Amberfield S92 Response

Landscape / Visual Effects / Open Space
Prepared for Weston Lea Ltd

17 August 2018

ASSOCIATION OF CONSULTING
ENGINEERS NEW ZEALAND

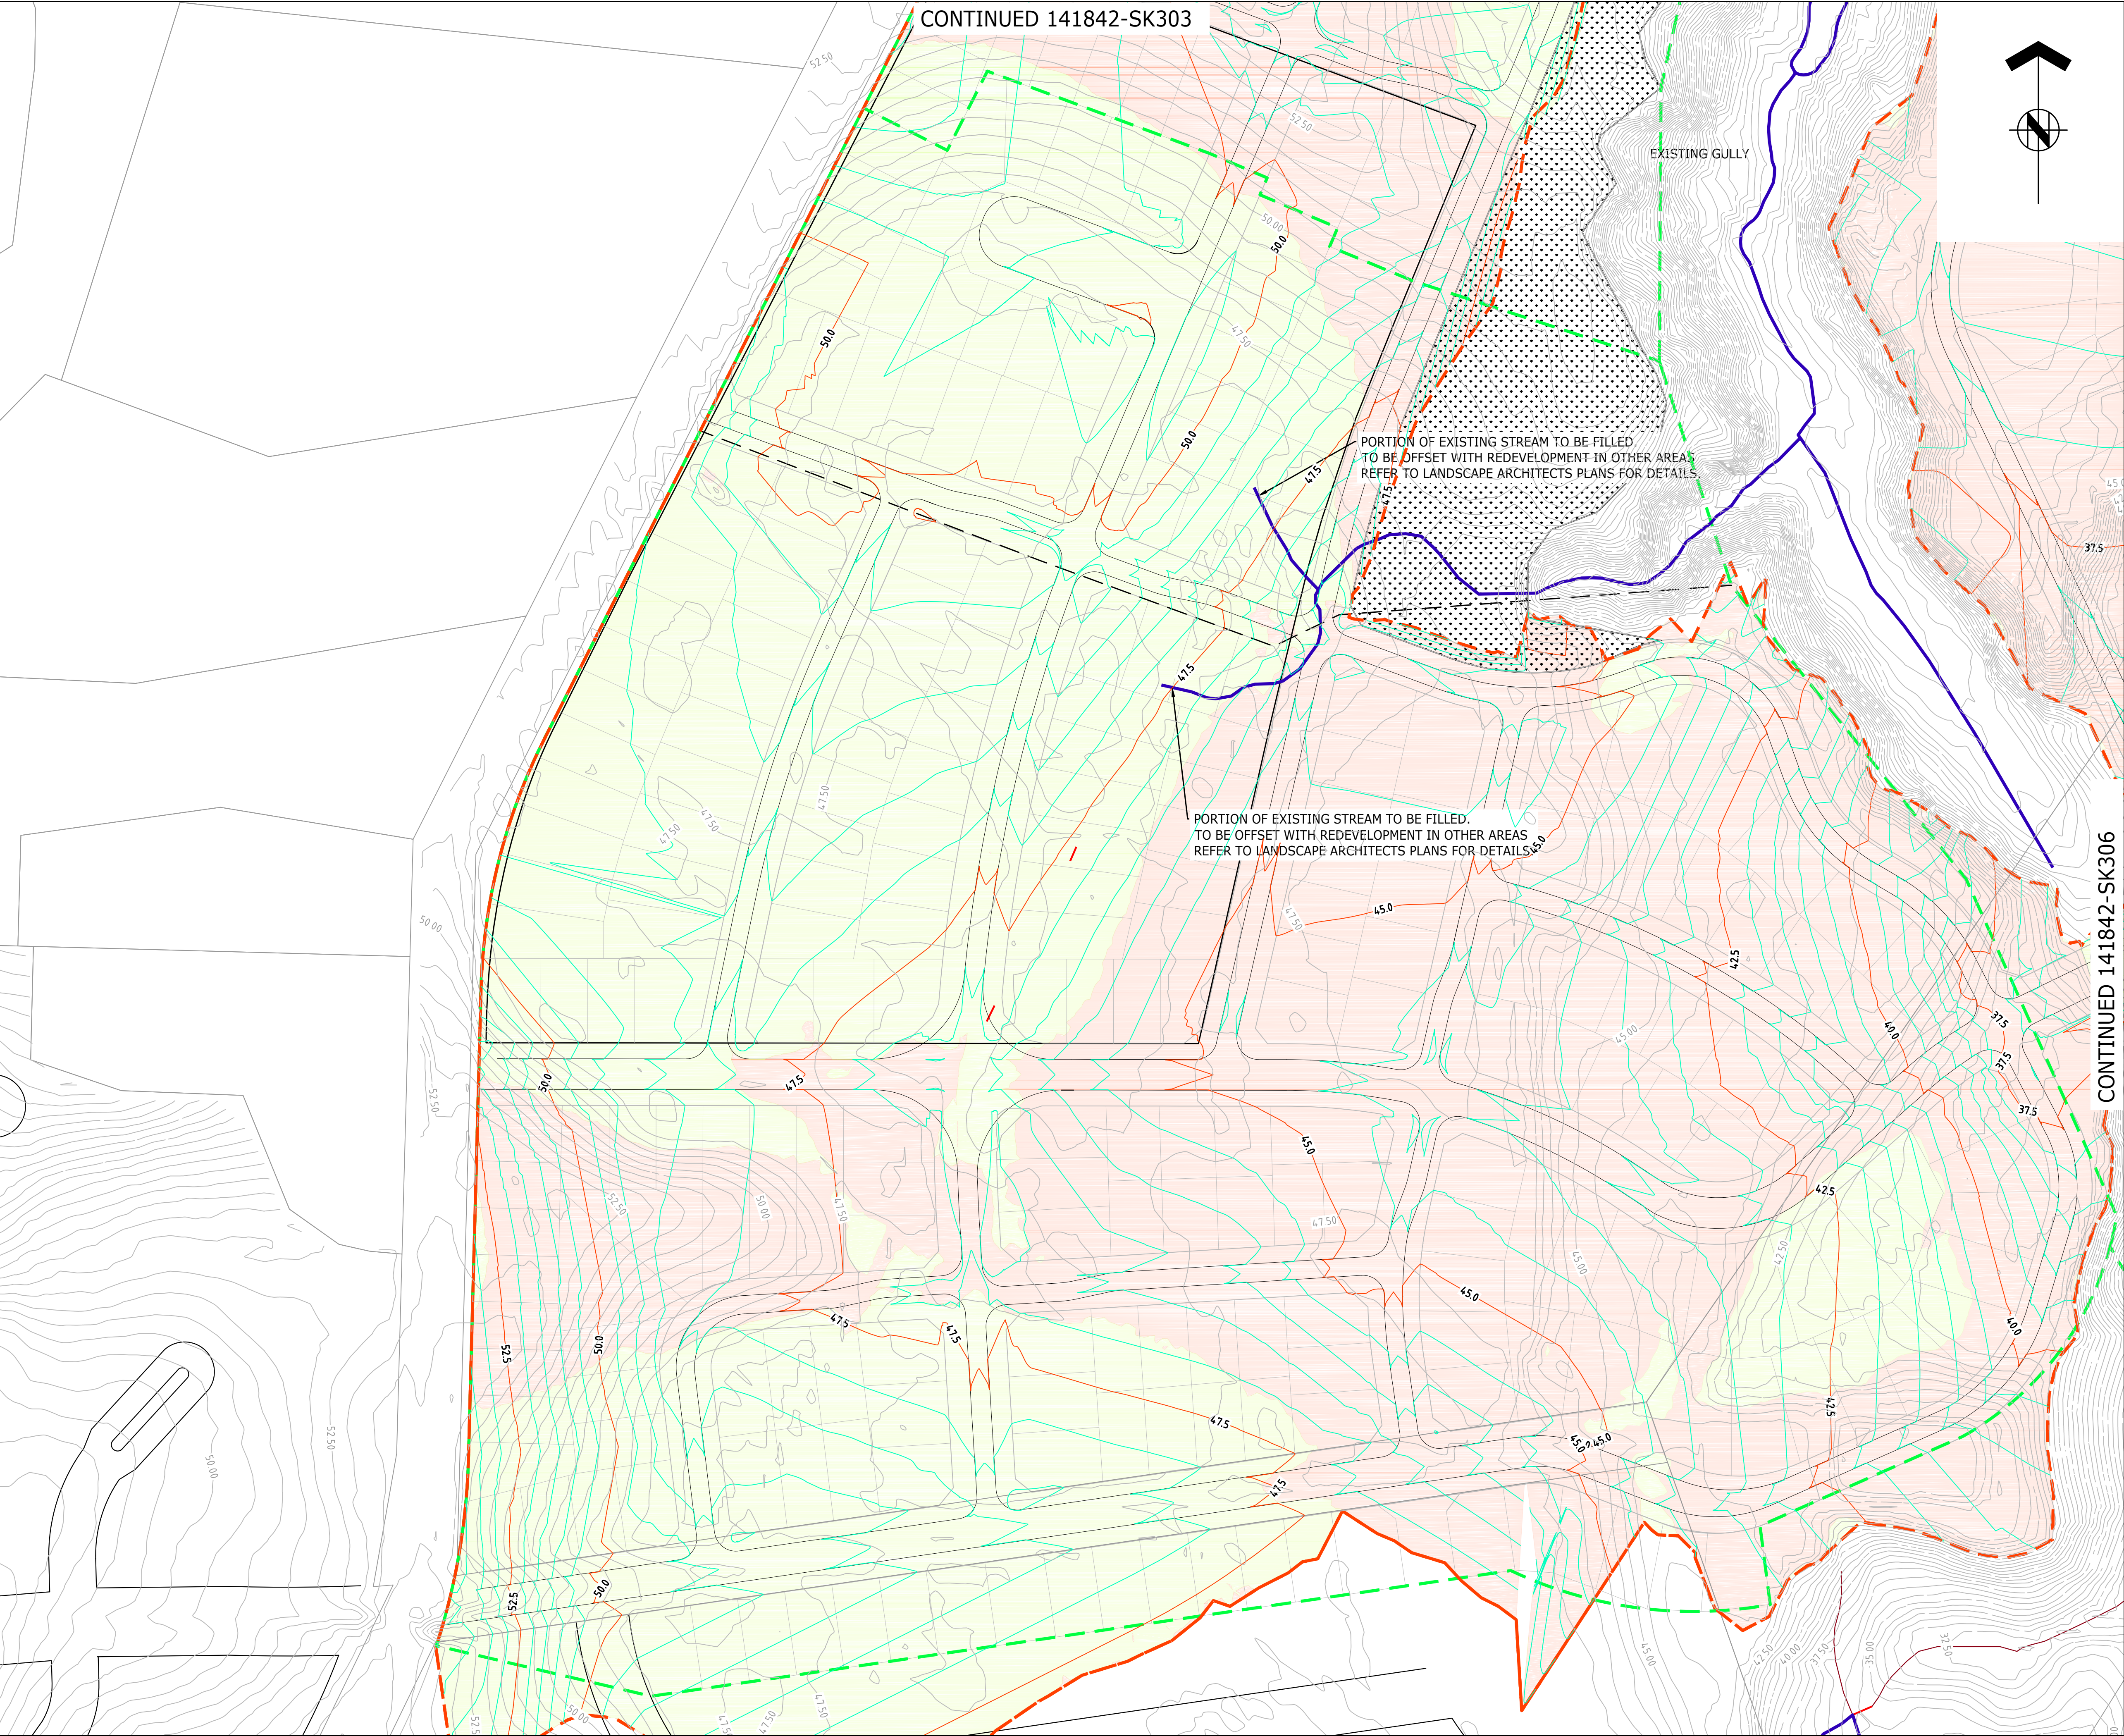
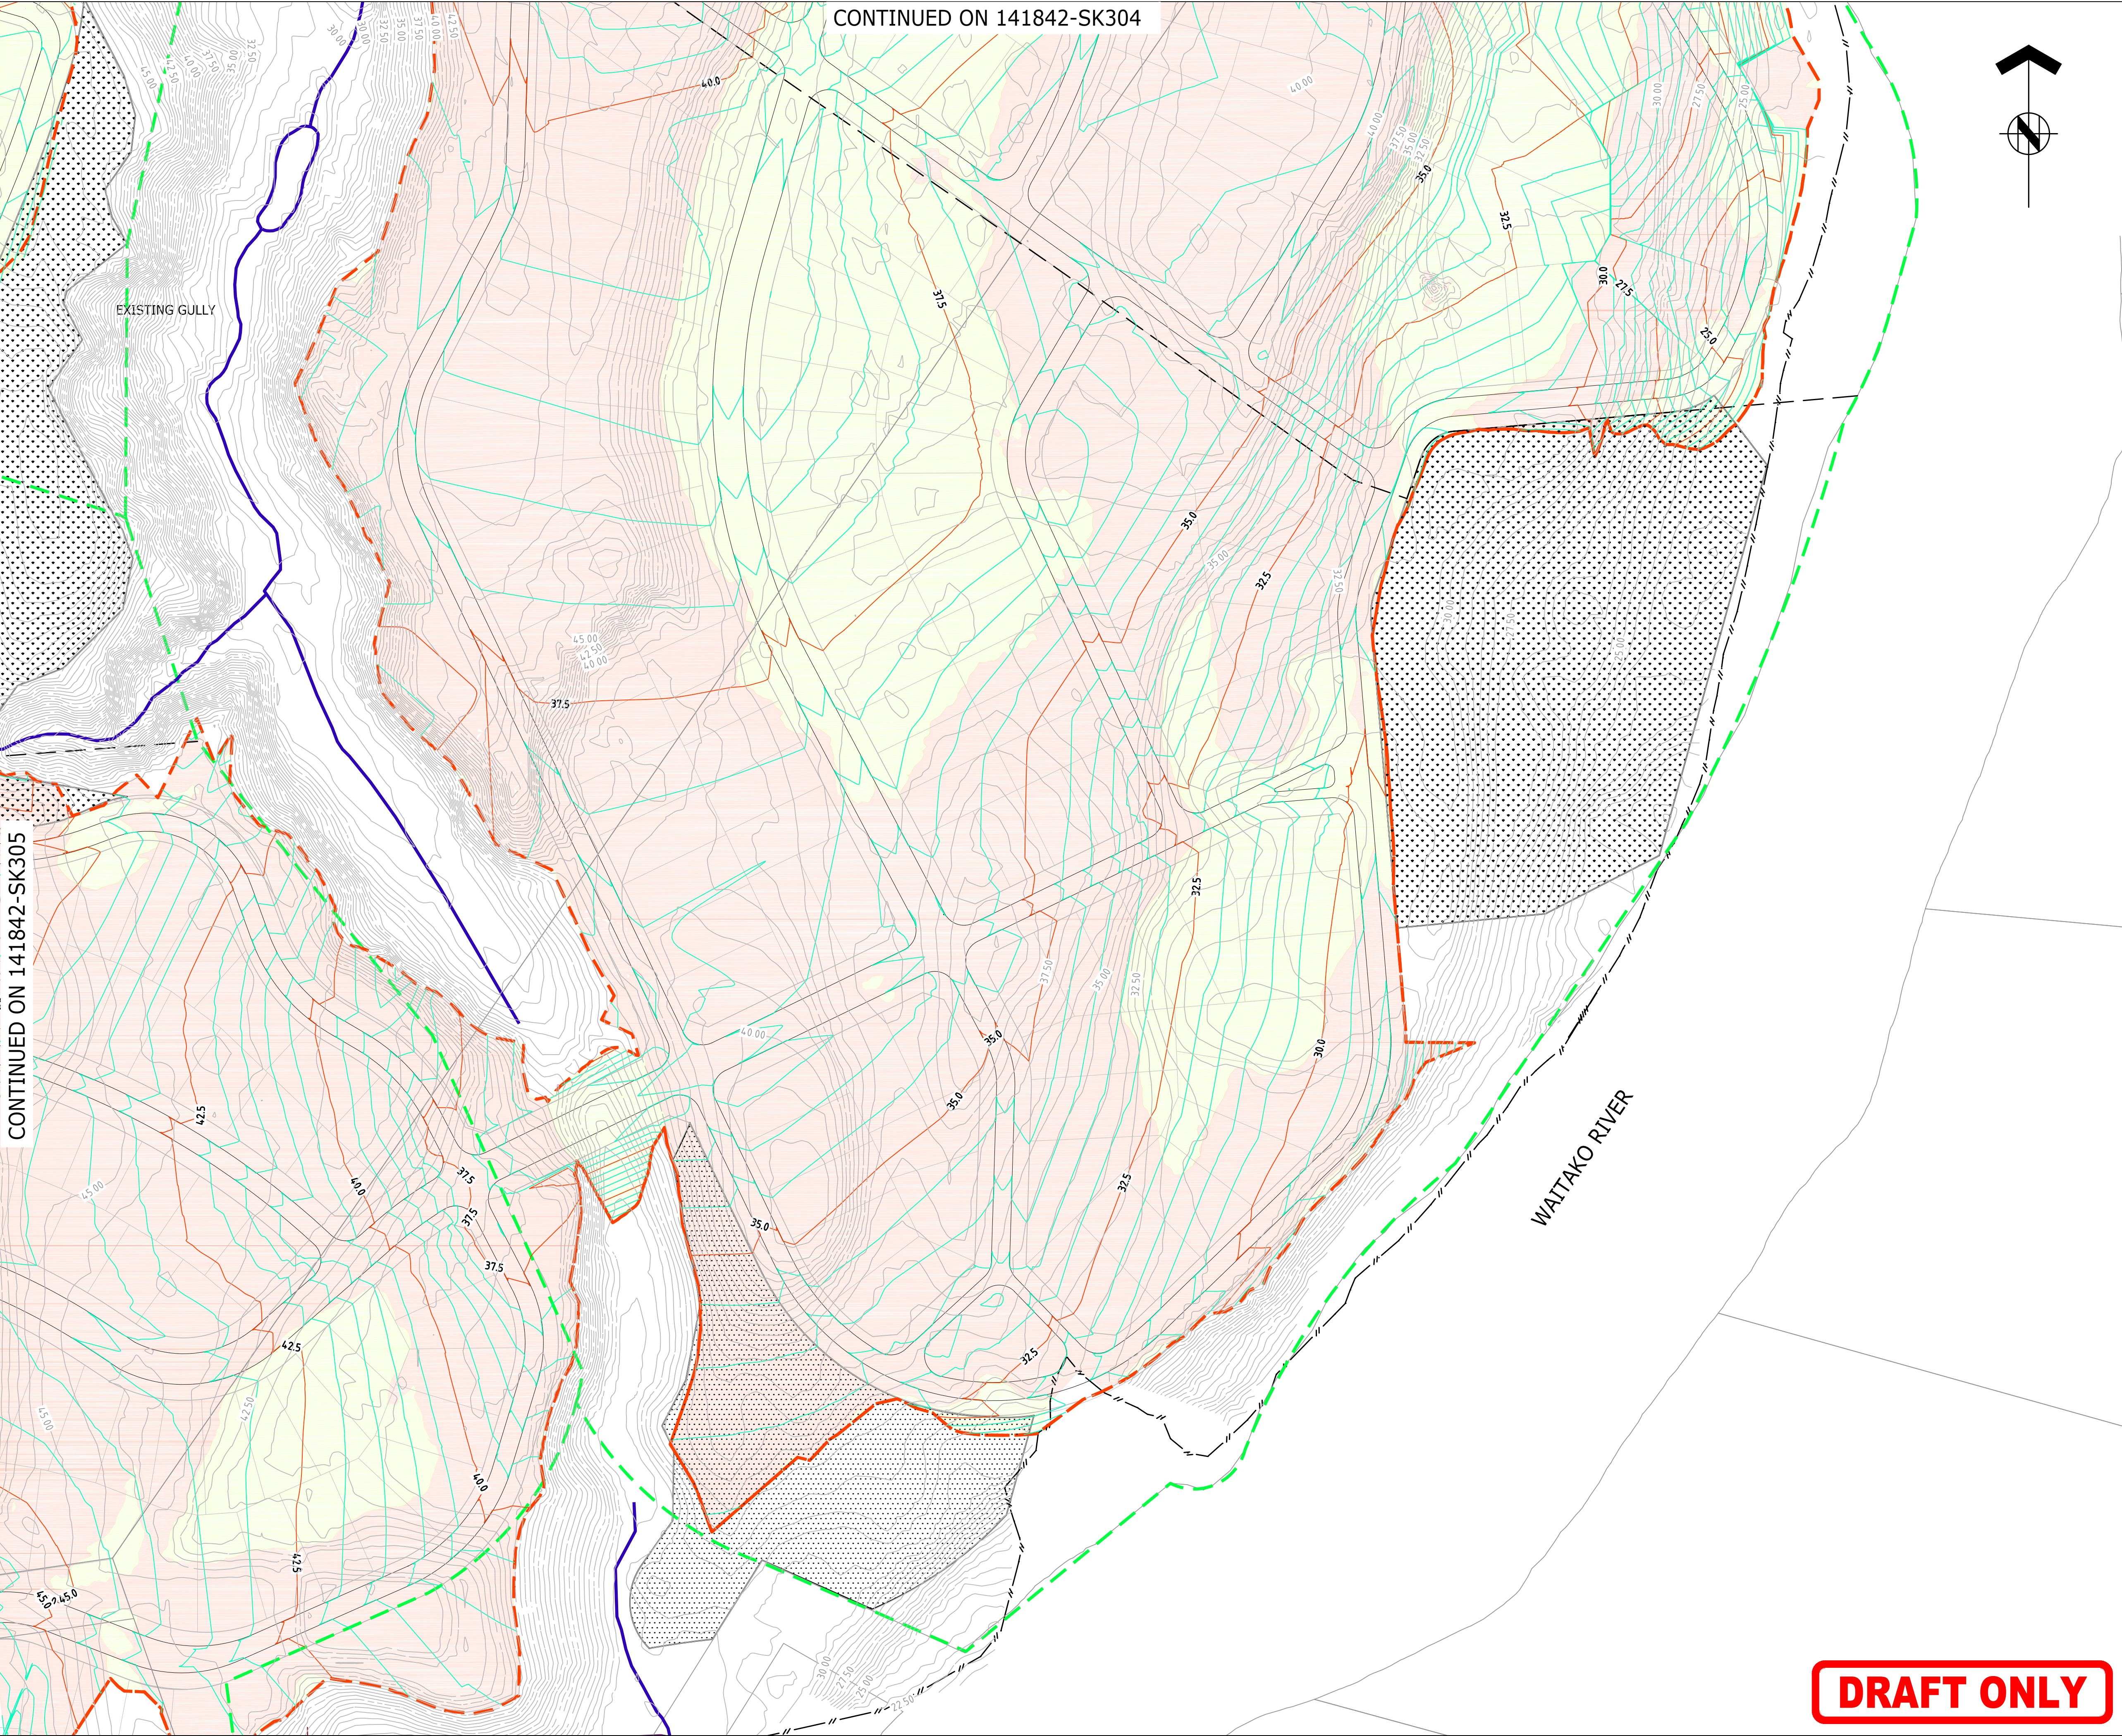
The additional H&G Cut and Fill drawings; 141842-SK301 to SK306, now clearly showing the existing and proposed contours, show the general smoothing off of the landform consistent with earthworks to enable urban development, the grading to achieve street gradients / connections and the proposed terracing of the site. As already noted the greatest level of modification is to 'The Island' landform which will remain strongly defined by the gully system to the west and river corridor to the east retaining the separate identity of this part of the overall site topography.
